DATE REVISED	DATE FILMED	DATE REVISED	DATE FILMED	FED. RD. DIST. NO.	STATE	FED. AID PROJ. NO.	SHEET NO.	TOTAL SHEETS
				6	ARK.			
						JOB NO. 070415	1	76
						BAYOU DERRISEAUX STRS. & APPRS. (S)

VICINITY MAP

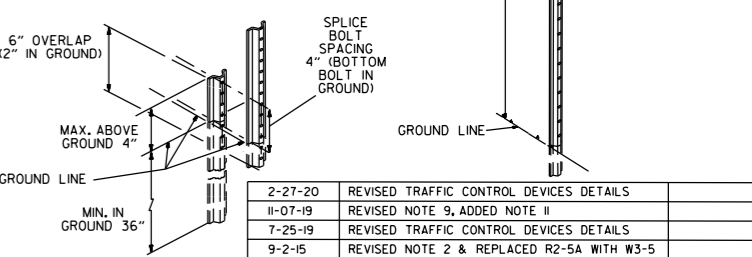
DATE	REVISION	FILMED
2-27-20	REVISED TRAFFIC CONTROL DEVICES DETAILS	
11-07-19	REVISED NOTE 9, ADDED NOTE II	
7-25-19	REVISED TRAFFIC CONTROL DEVICES DETAILS	
9-2-15	REVISED NOTE 2 & REPLACED R2-5A WITH W3-5	
10-15-09	ADDED REFERENCE TO MASH	
11-20-08	REVISED SIGN DESIGNATIONS	
11-18-04	ADDED NOTE	
10-1-98	ADDED NOTE	
4-03-97	ADDED (SP) TO W6-18 & REVISED TRAFFIC CONTROL DEVICES NOTE	
10-18-96	ADDED R55-1	
10-12-95	MOVED UPPER SPLICE	
6-8-95	REVISED SPLICE DETAIL, TEXT	6-8-95
2-2-95	REVISED PER PART VI, MUTCD, SEPT. 3, 1993	
8-15-91	DRAWN AND PLACED IN USE
